Our Reference: NP25.203
TCC Reference: MCU26/0051
HF

**Response to Information Request
Development Application for Material Change of Use – Multiple Dwelling (10 units) &
Extension to Existing Place of Worship
18 Hinchinbrook Drive, Thuringowa and formally identified as Lot 23 on T118666**

Response to Information Request

Title : SITE PLAN
Date: 03.06.26 Drawn: DE
Scale: 1 : 750 Designed: N.H
Job No: 2025-255-C
Drawing No: DD 02 Rev. 7

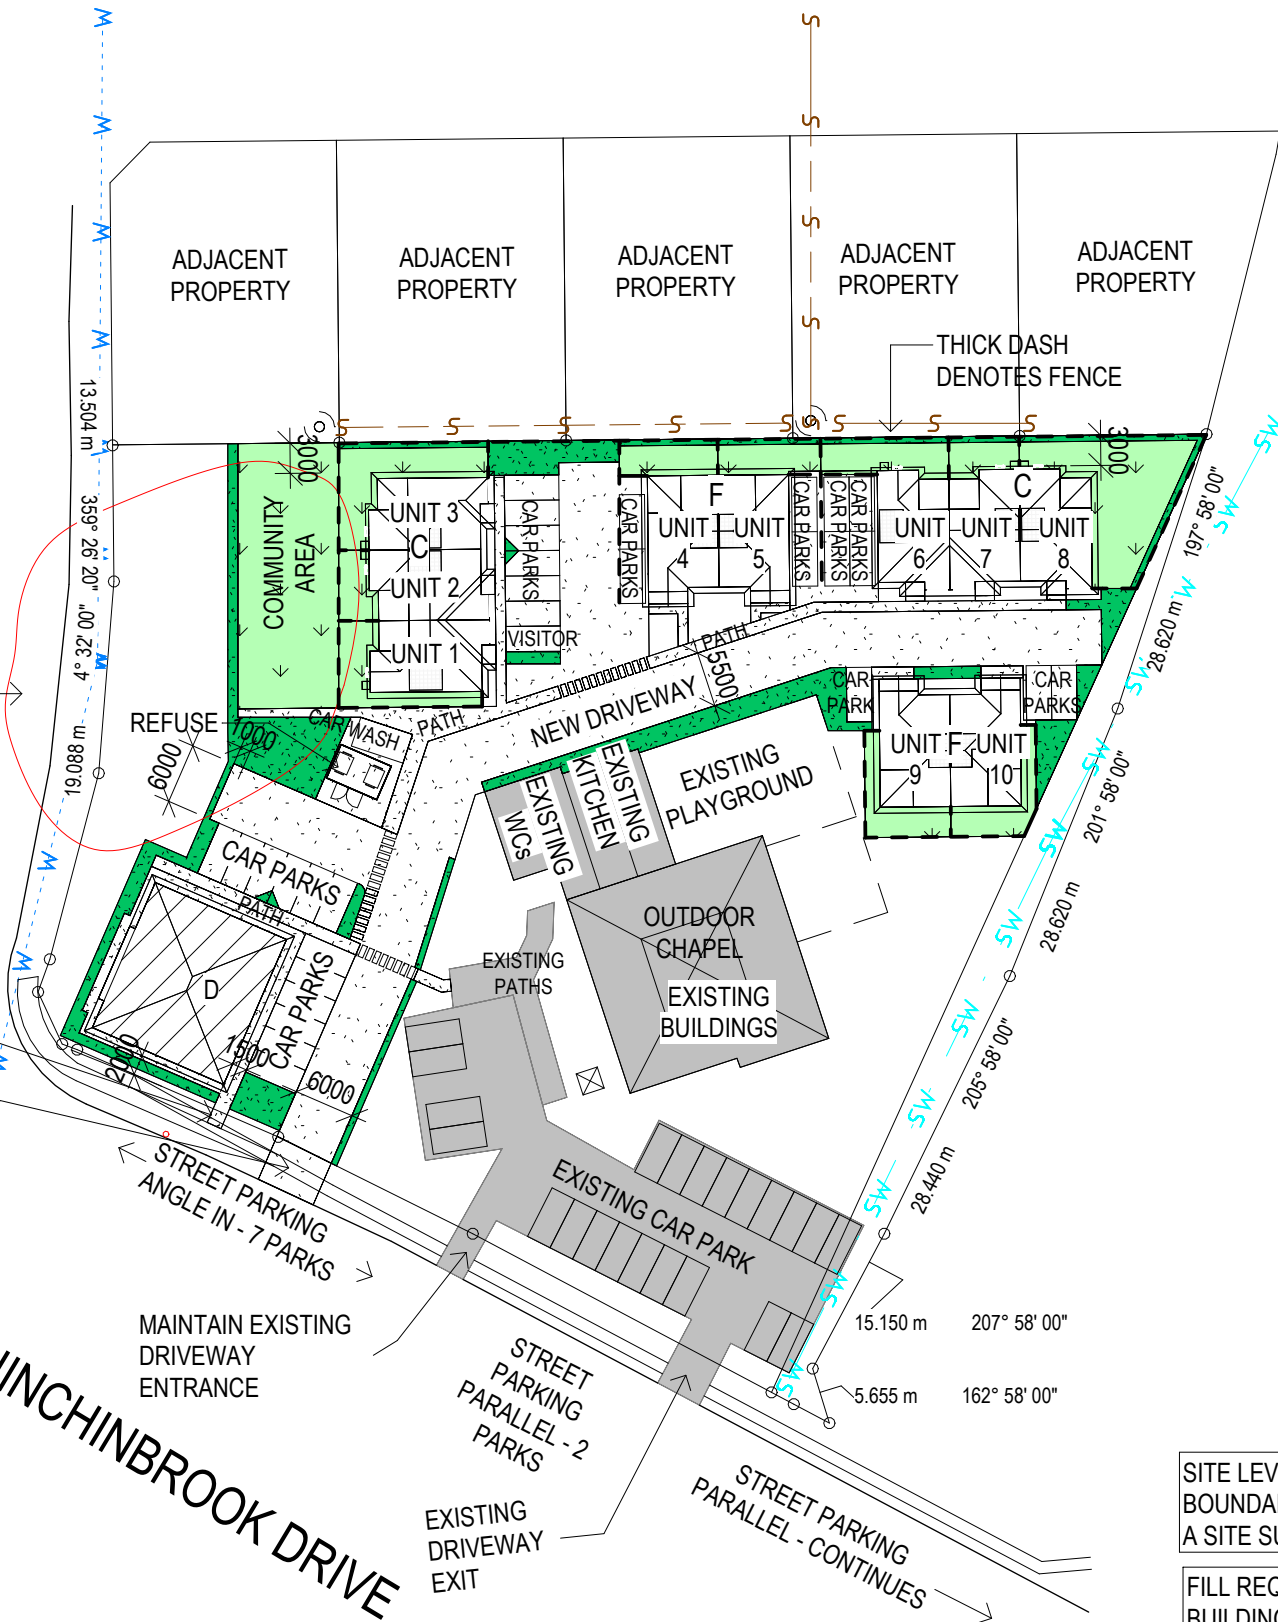
This item requires the applicant to provide further detail on pedestrian access to Corveth Street and the plaza to the east, whilst maintaining the privacy of future residents.

The applicant is requested to provide further detail to how pedestrian access to Corveth Steet will occur on site to the plaza to the east whilst retaining the privacy of the residences on site.

The amended plans identify pedestrian pathways throughout the site, connecting the proposed residential units, community centre and existing Place of Worship.

The pedestrian pathways will be separated from private residential areas through landscaping and fencing, providing visual screening to maintain the privacy of future residents. The site layout also provides for casual surveillance of pedestrian areas, with windows and openings overlooking internal pathways and shared areas.

The proposed arrangements are considered to provide safe and convenient pedestrian access without compromising the privacy and amenity of future residents.

Please refer to the amended plans at **Attachment 2**.

Title : LANDSCAPE PLAN

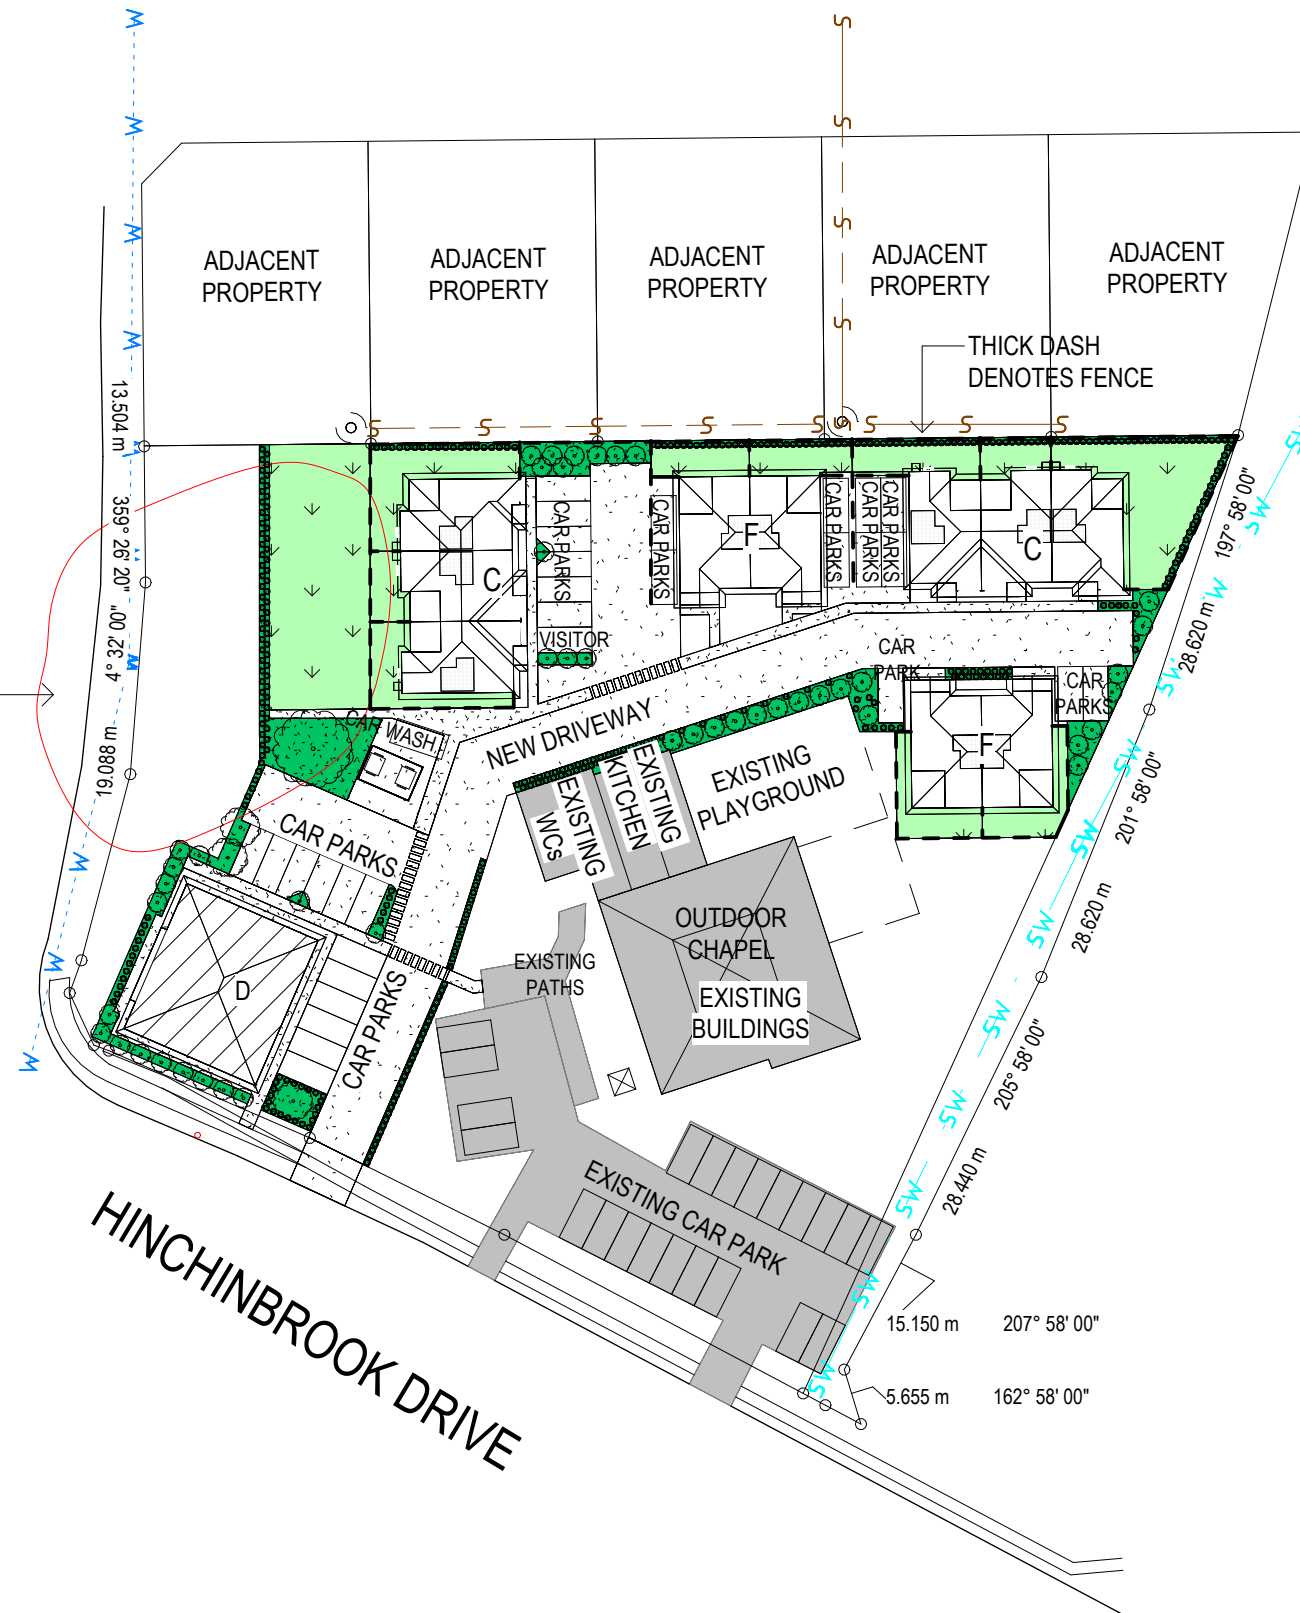
This item requires the applicant to amend the plans to provide shade trees within car parking areas and screen planting to private residential areas and adjoining properties.

The applicant is requested to amend the plans to allow for shade trees in the areas for car parking and screen planting for private areas and buffers to residential areas internal and external to the site.

The amended landscape plan identifies landscaped areas throughout the development, including planting adjoining car parking areas, internal pedestrian pathways and residential interfaces.

The proposed planting will assist in providing visual screening between private and shared areas, softening the built form and improving the overall amenity of the development.

Please refer to the amended landscape plan at **Attachment 2**.

Figure 4: On-site Sources to On-site Receivers - Daytime Leq15min - Grid Map

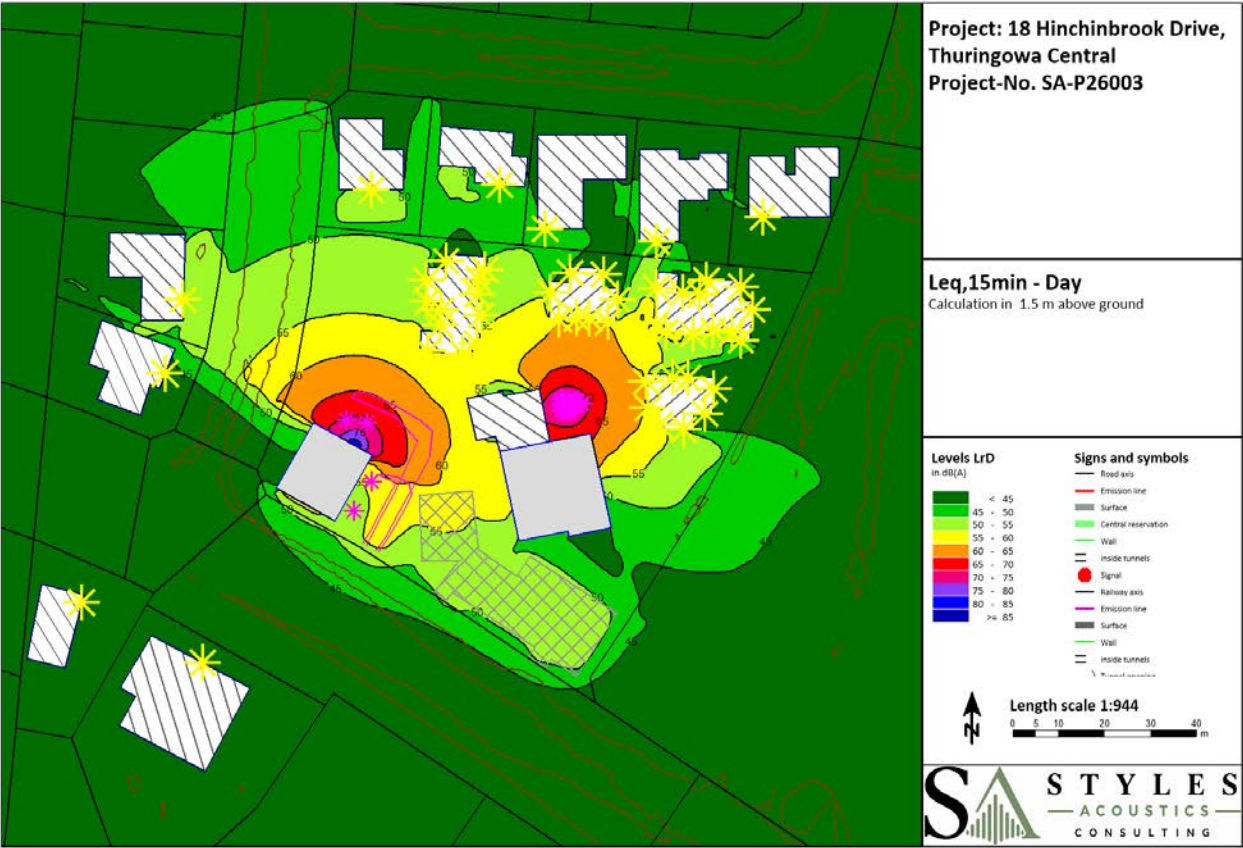
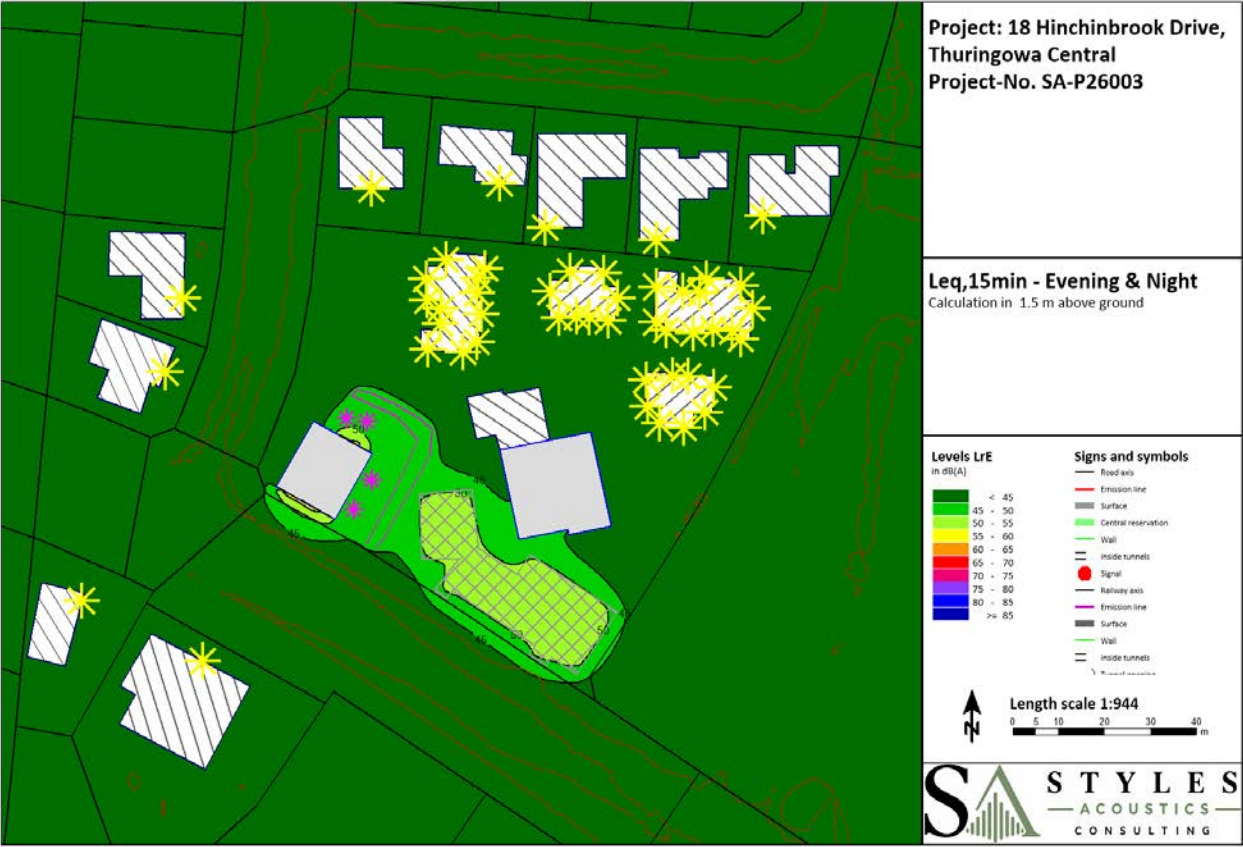
The applicant is requested to provide a noise impact assessment for the extra 21 people on site, both to adjoining residences west and north of the site, and internally from the adjoining uses and the place of worship impact on the future residents.

The predicted noise levels exceed the applicable acoustic quality objectives at the onsite receivers. Acoustic recommendations for the building façades of the affected onsite units are provided in Section 8 to achieve suitable internal noise levels.
